**DRAWING AMENDMENTS**

**BEST AVAILABLE COPY****REMARKS**

In response to the Office Action dated Dec. 1, 2005 please amend the application as follows:

TITLE: LETTER COVER  
 INVENTOR: JYCKE V. PAAVILA  
 SER. NO. 10/802,337

Fig-2

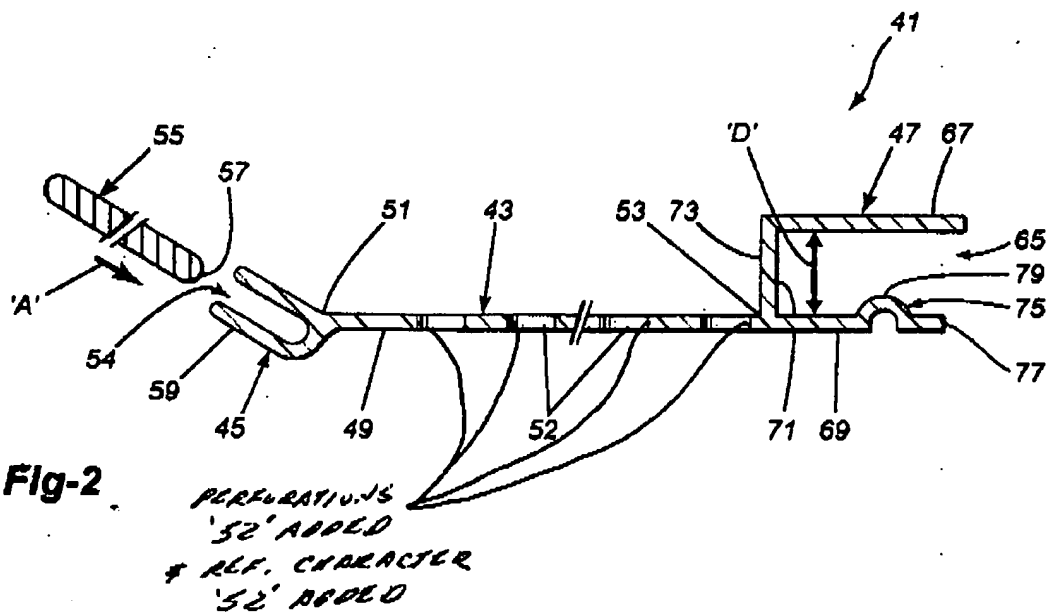
Fig. 2 has been amended to show perforations 52 in the panel of the gutter cover. A fresh sheet incorporating the change is attached along with a marked up sheet showing the change.

In the drawings, amend Fig. 2 to show perforations 52. See DRAWING AMENDMENTS.

The drawing amendment is believed to overcome the objection raised in para. 1 of the Action.
